City of Portland, Maine - Building or Use Permit Application

Permit No: 02-0062	Issue Date: FEB 5 2002	CBL: 430 A019001
-----------------------	---------------------------	---------------------

Past Use: Single Family	Proposed Use: Single Family / Amendment to permit # 01-0554. Window changes, gas fire, bath revision and delete bedroom.	Permit Fee: \$30.00	Cost of Work: \$0.00	CEO District: 2
Proposed Project Description: Amendment to Permit # 01-0554. Alterations		FIRE DEPT: <input type="checkbox"/> Approved <input checked="" type="checkbox"/> Denied <i>N/A</i>		INSPECTION: Use Group: <i>R-3</i> Type: <i>SB</i> <i>BOCA 1991</i>
		Signature: <i>[Signature]</i>		Signature: <i>[Signature]</i>

1st Floor
A+B Chapman
20 Berwick St
1/4" = 1'0"
4/6/01
rev. 12/28/01

$\frac{1}{4}" = 1'0"$
 A+B Chapman
 20 Berwick St.
 rev. 12/28/01

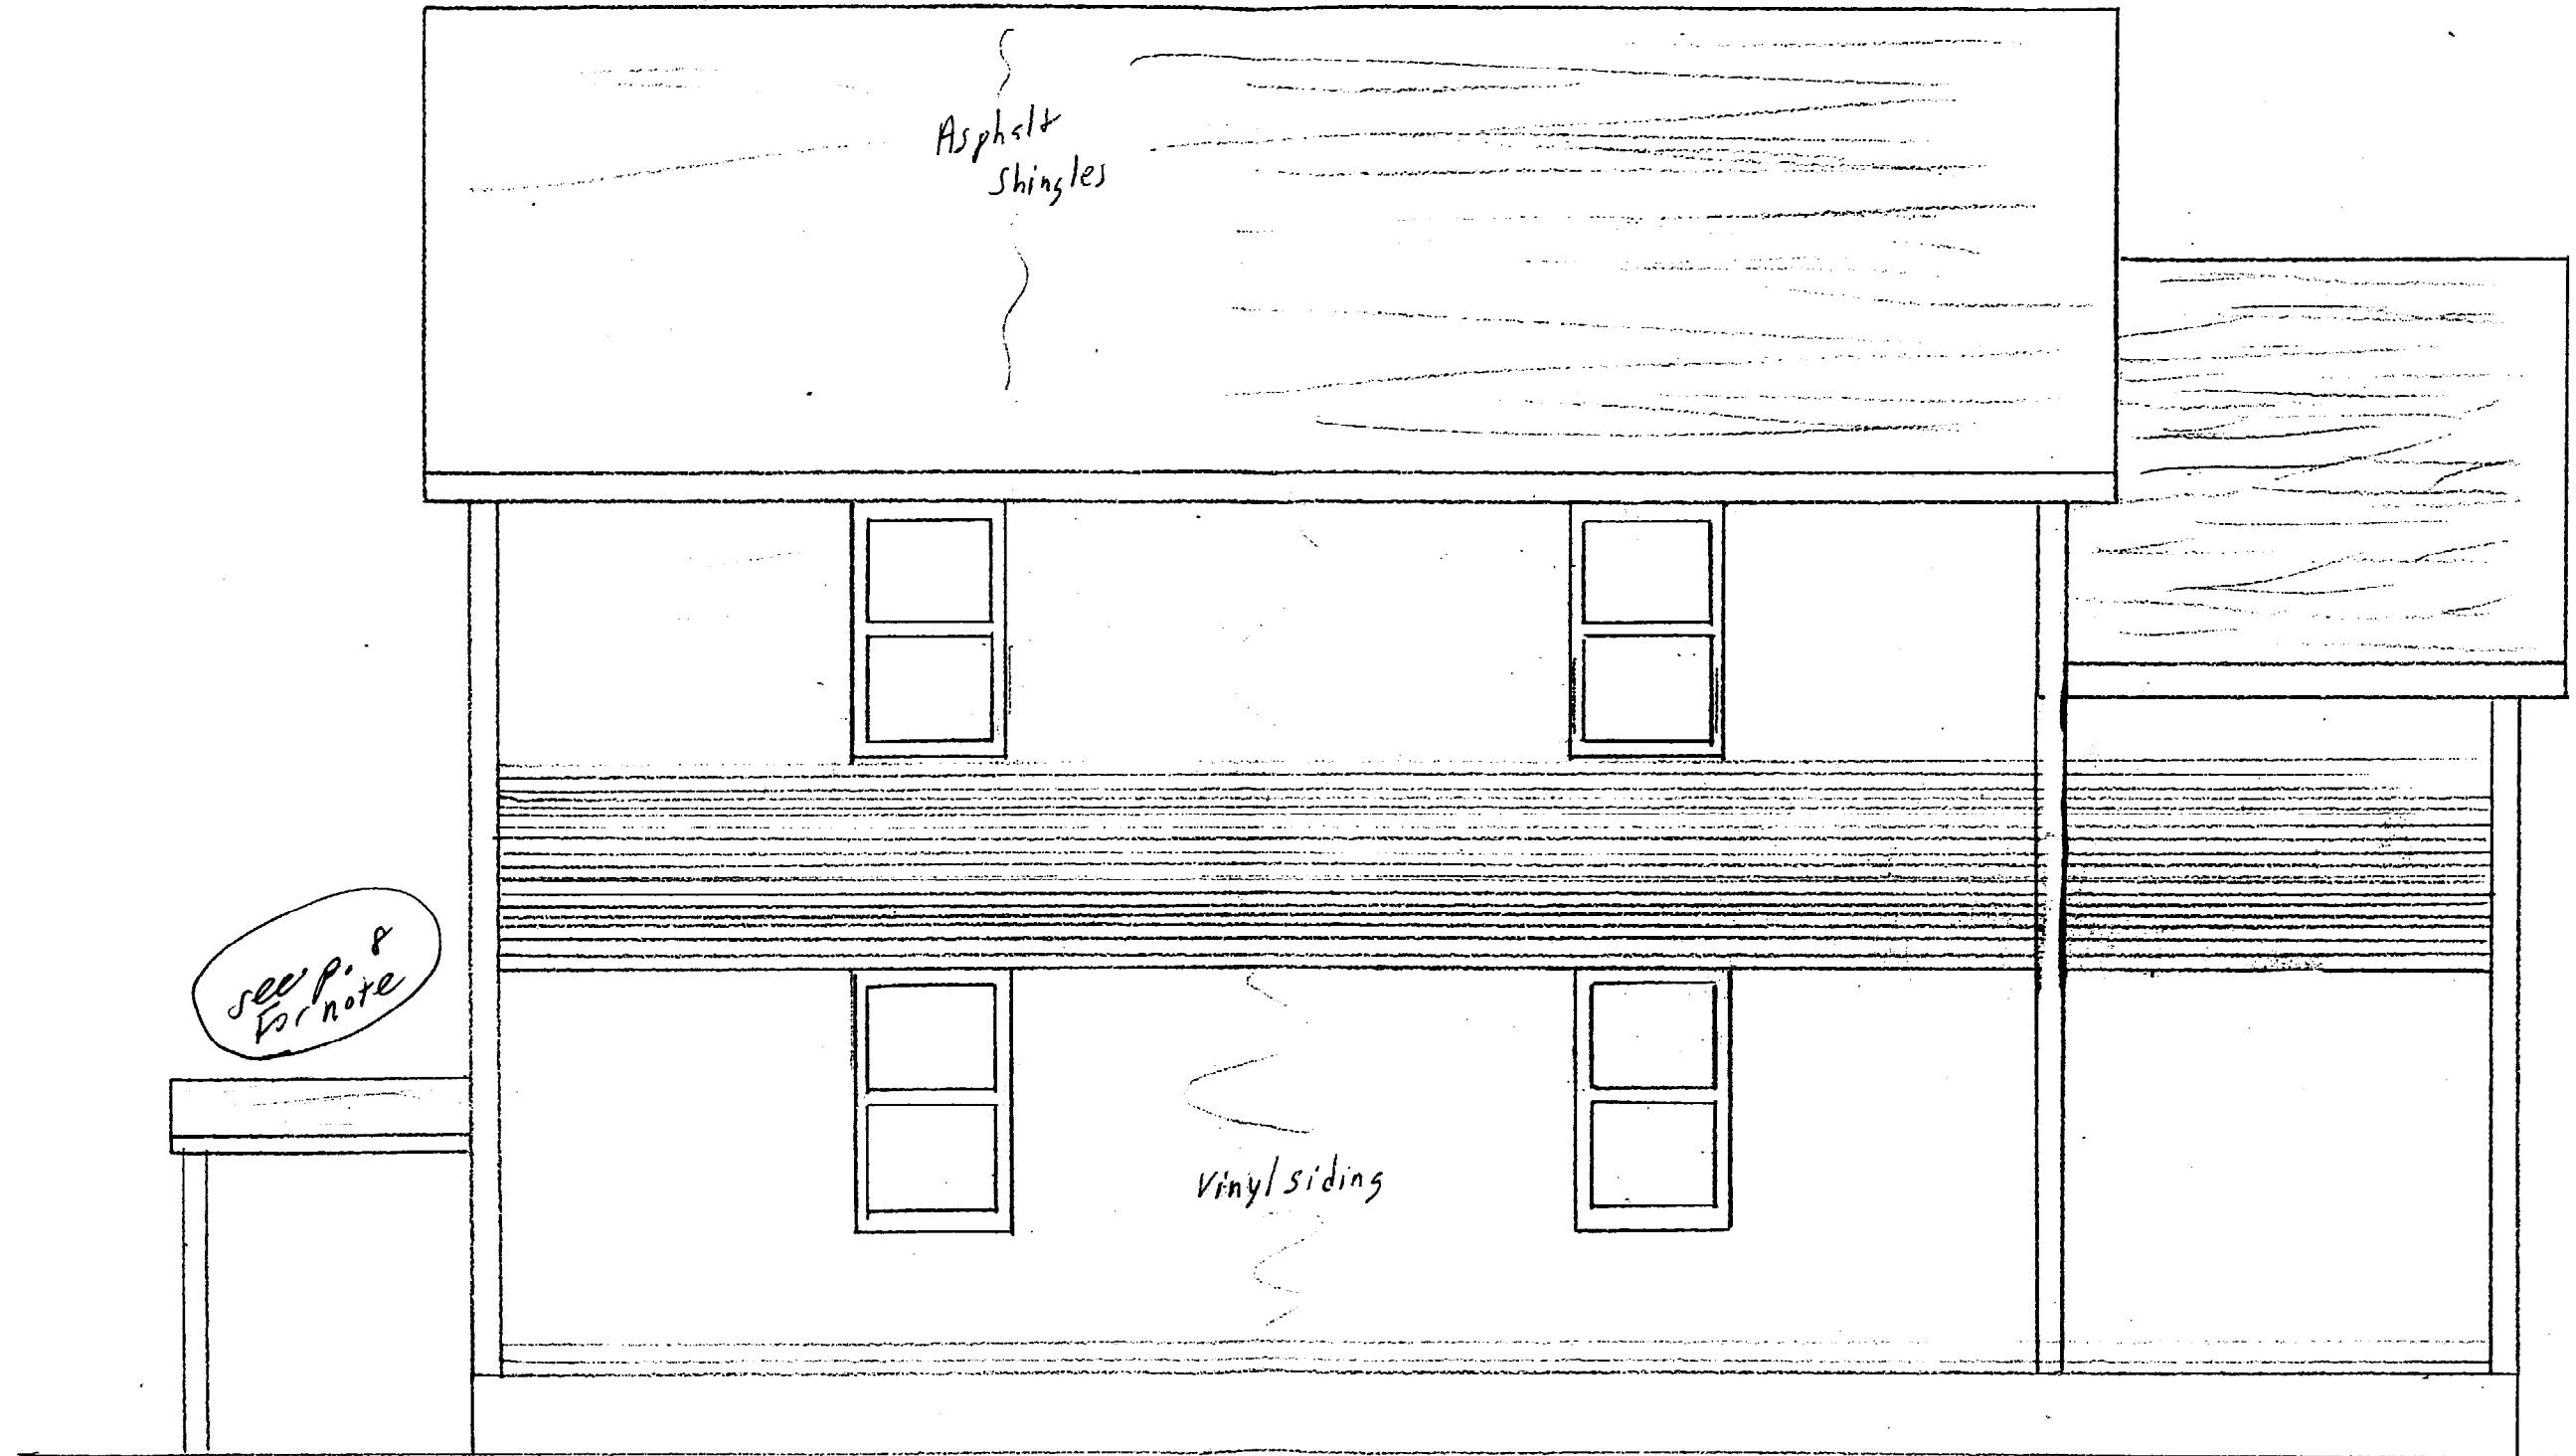
rev. Notes
 X Deleted window in kitchen to allow for look up venting
 X Noted to see p. 8 on cellar way

rev. 12/28/01

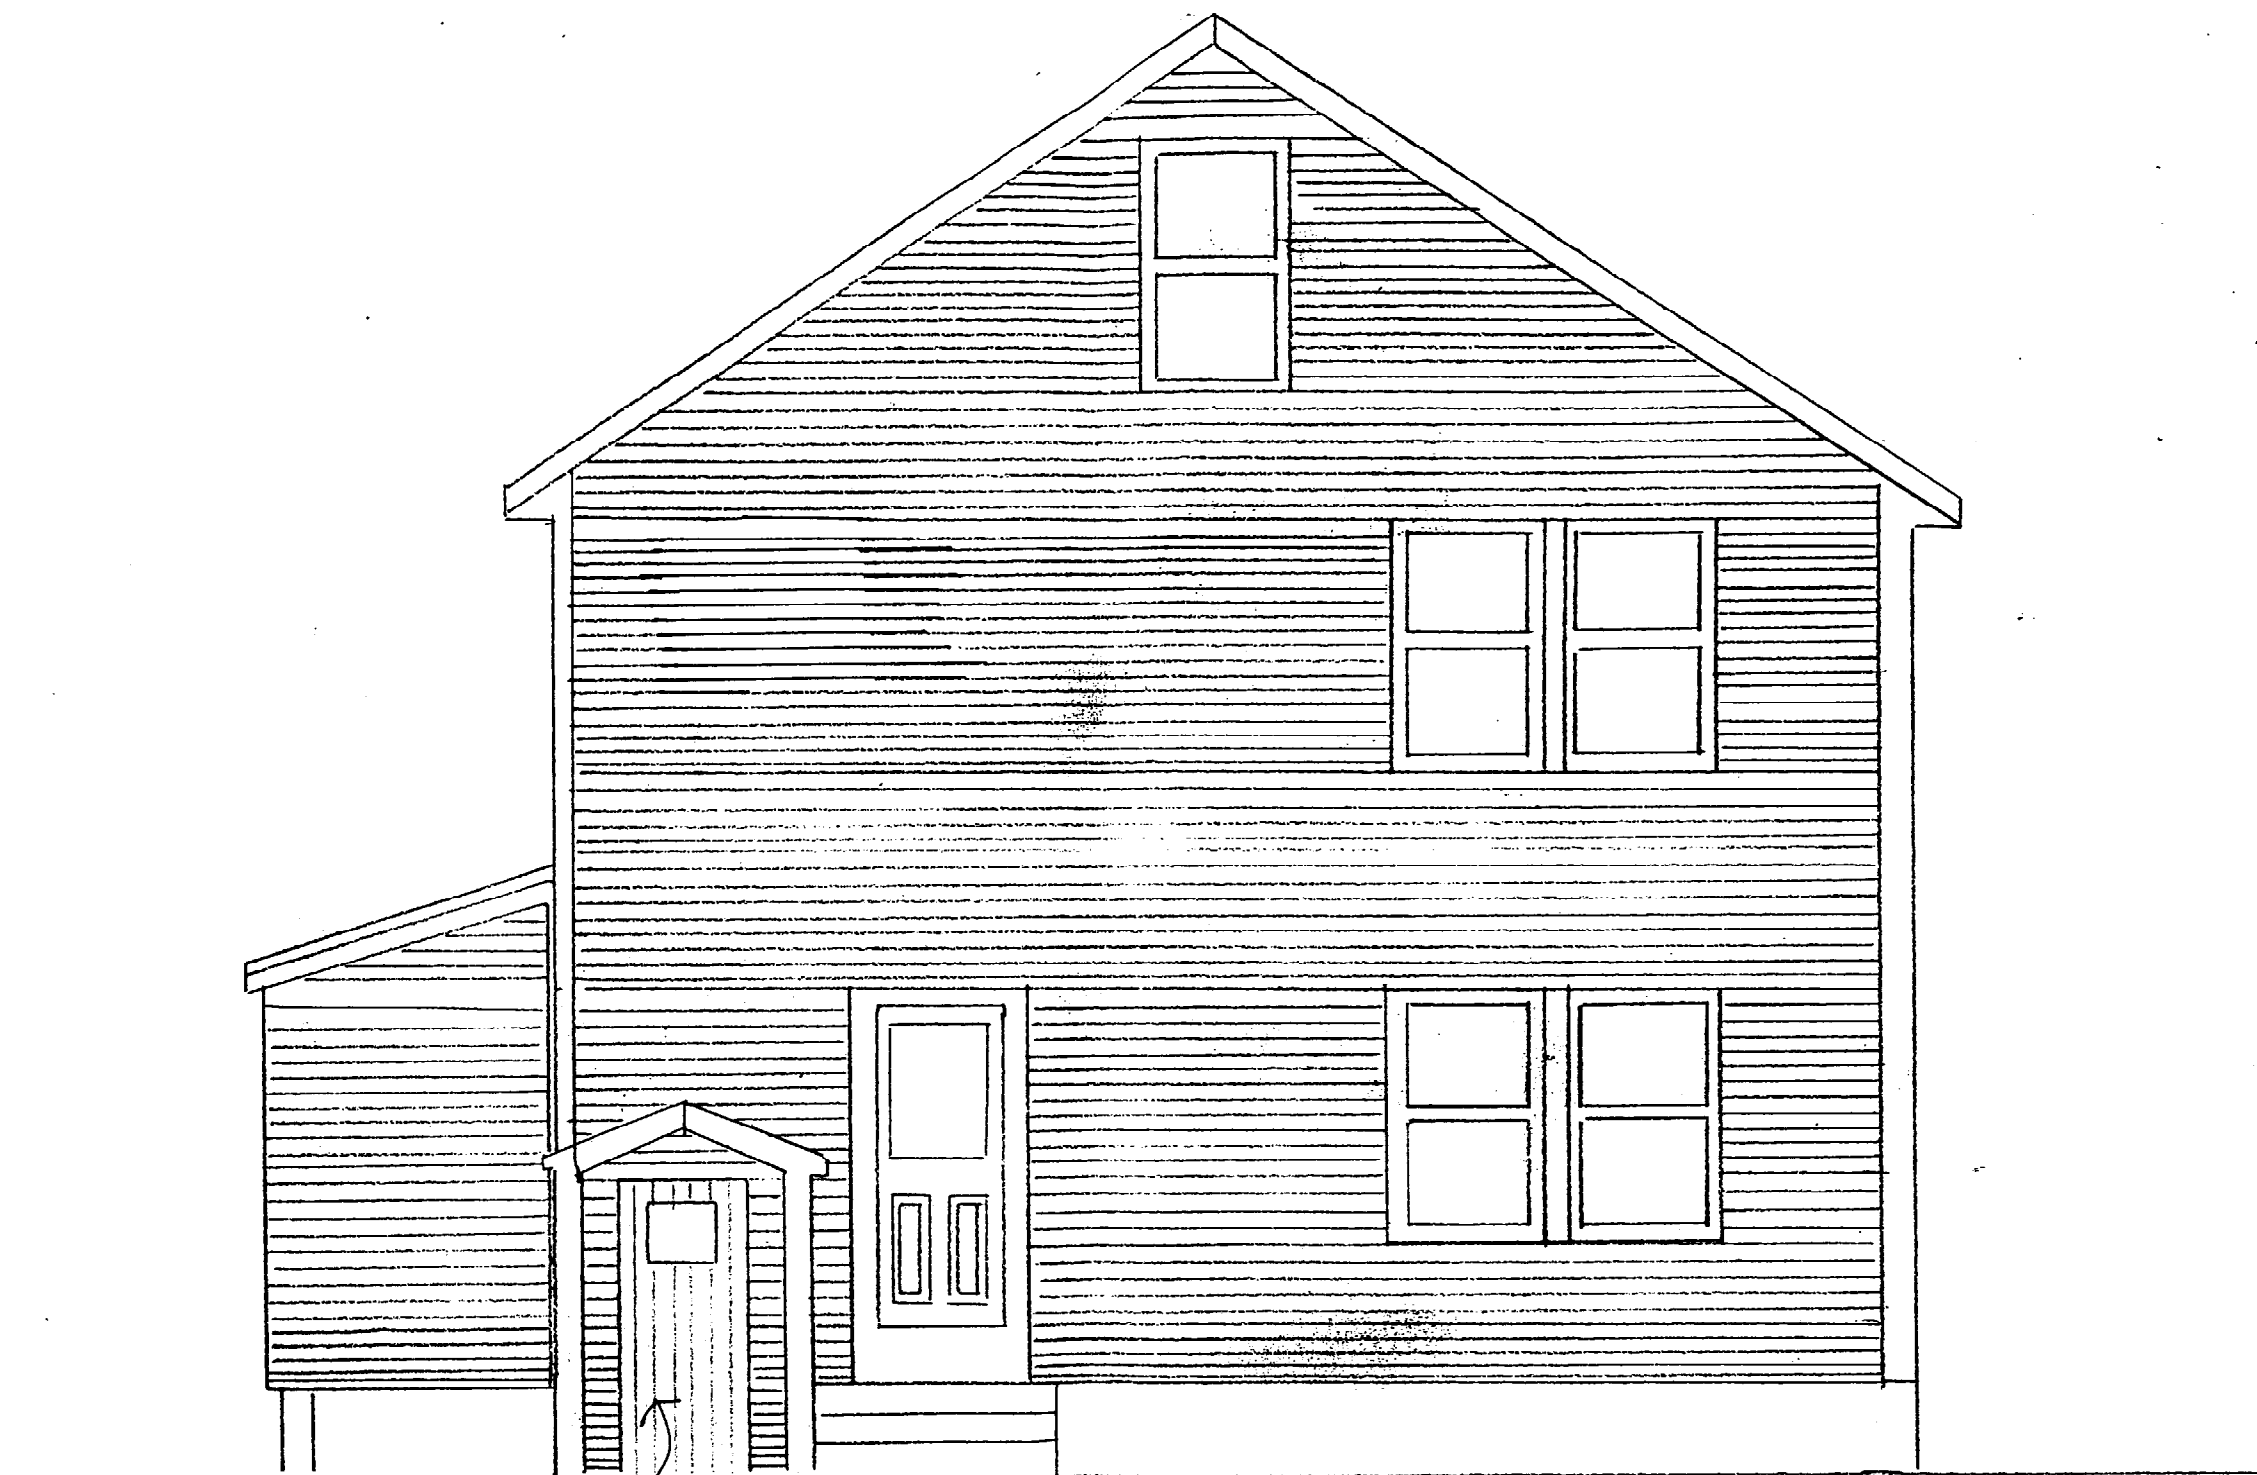
Note: roof
railed to Allow for
6'8" tall Door
to cellar

rev. Note
X Added note on cellar way
X deleted window in porch

Section A
A+B Chapman
20 Berwick St.
4/23/01
 $\frac{1}{4}'' = 1'0''$

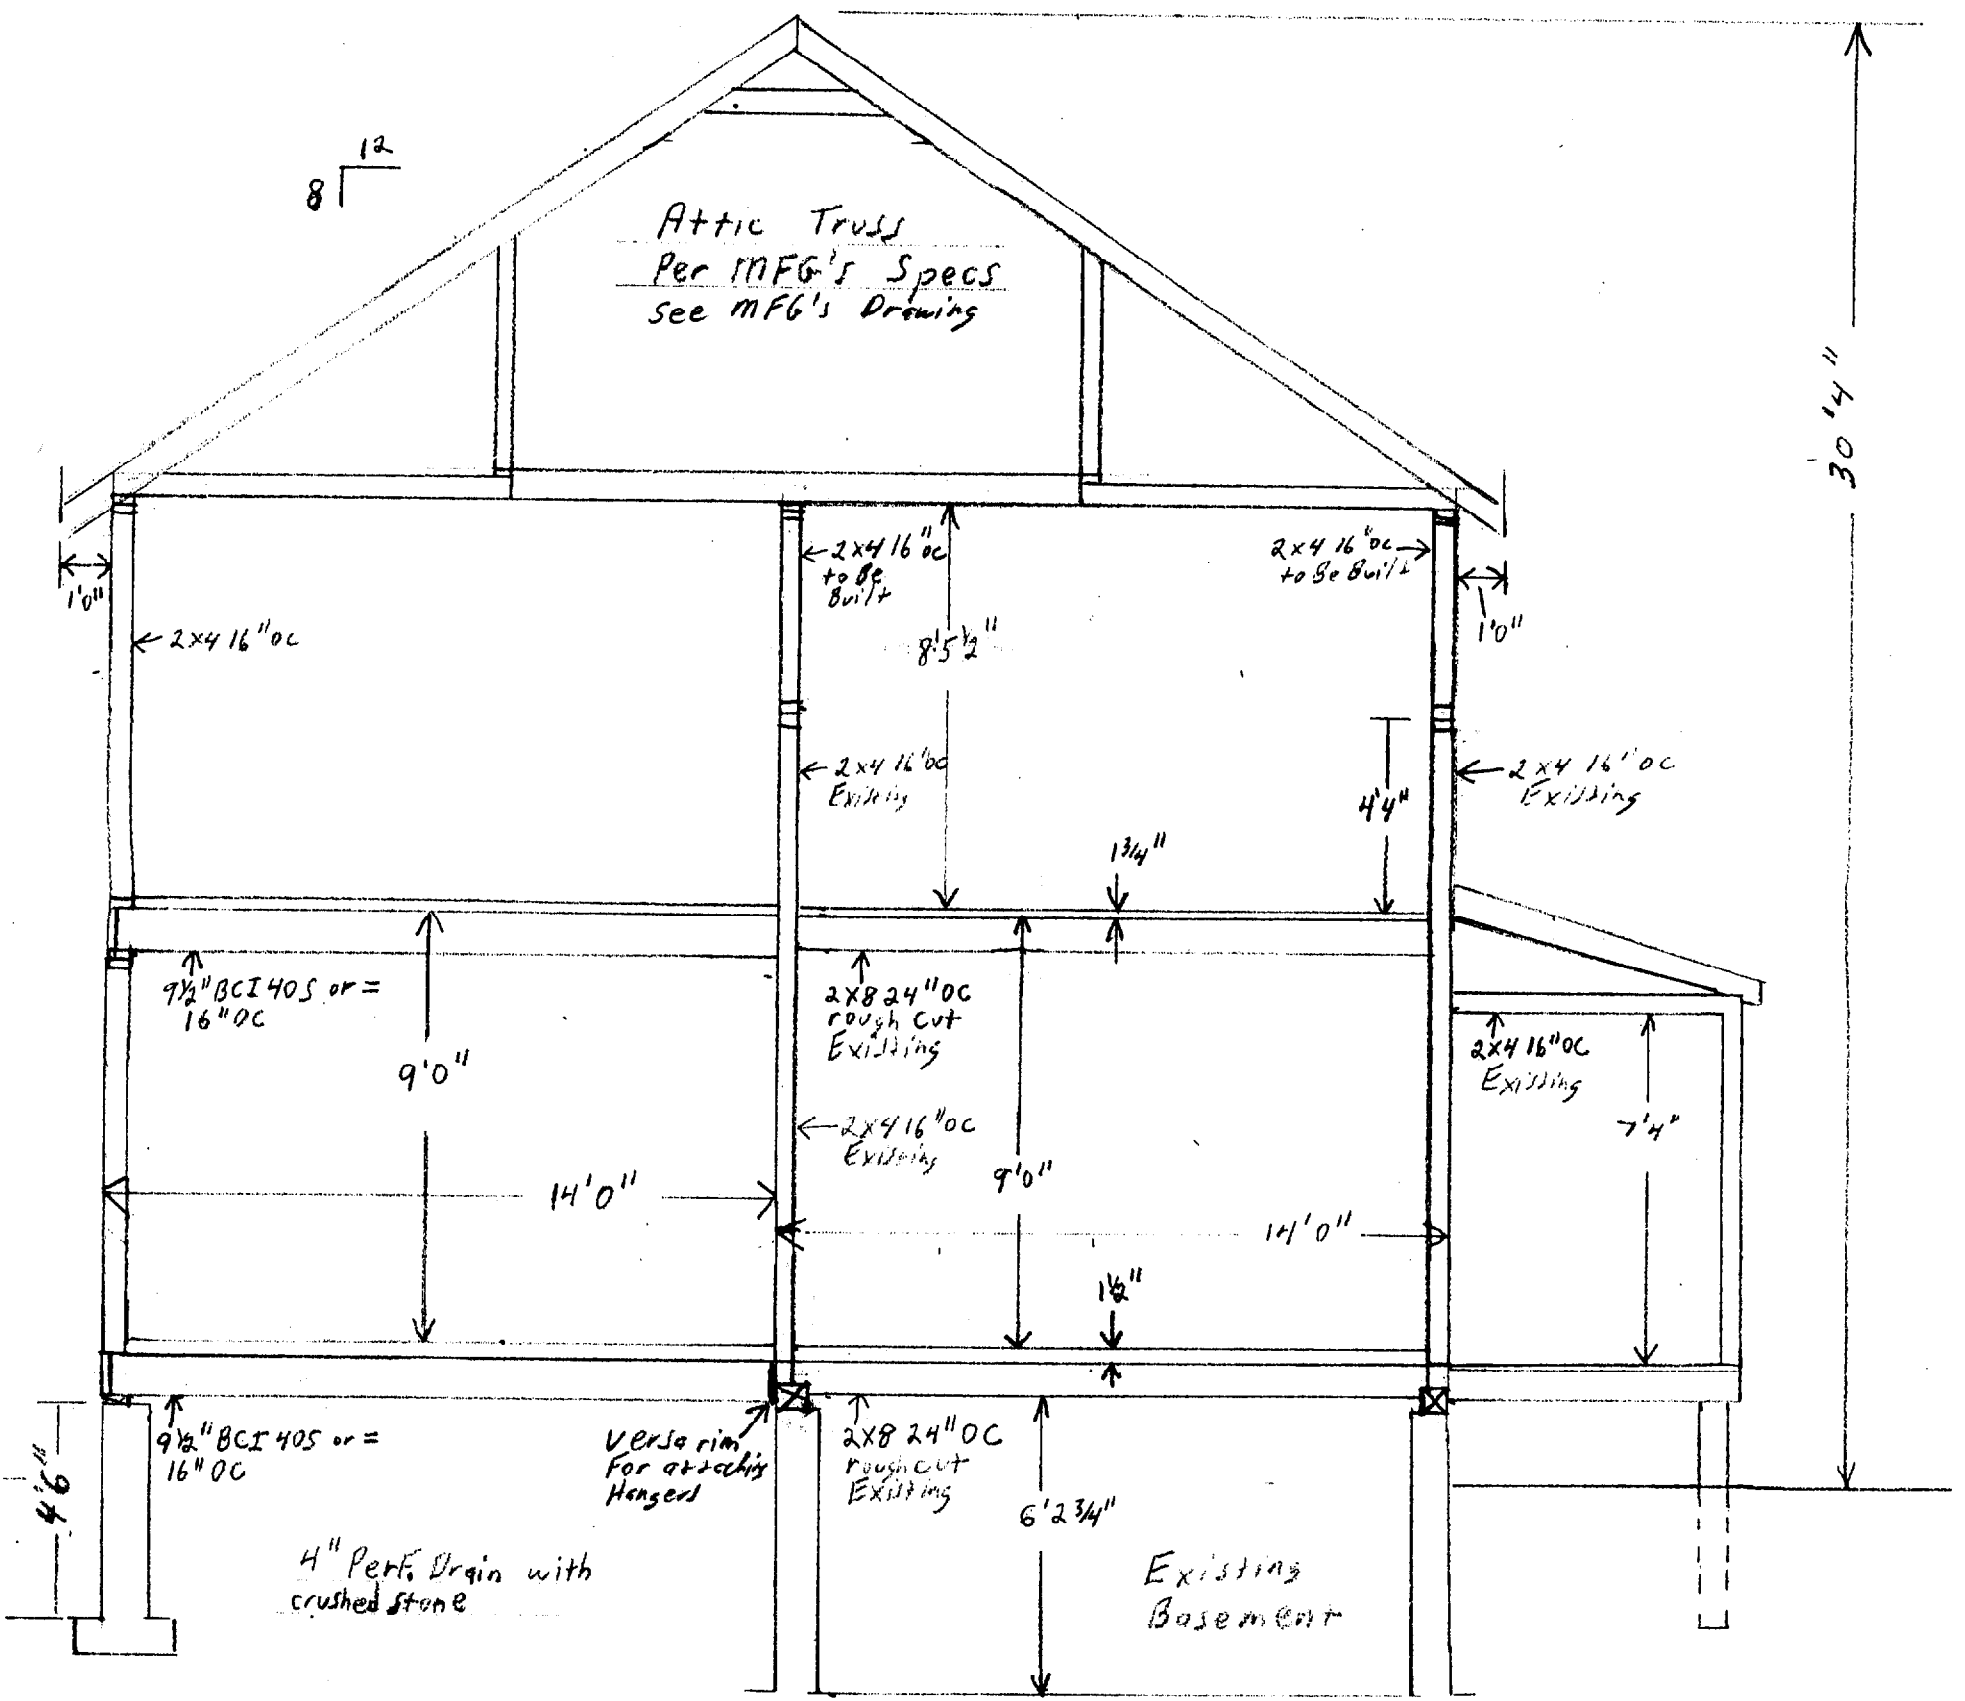
rev Notes:
X added slightly added 47
X added 08
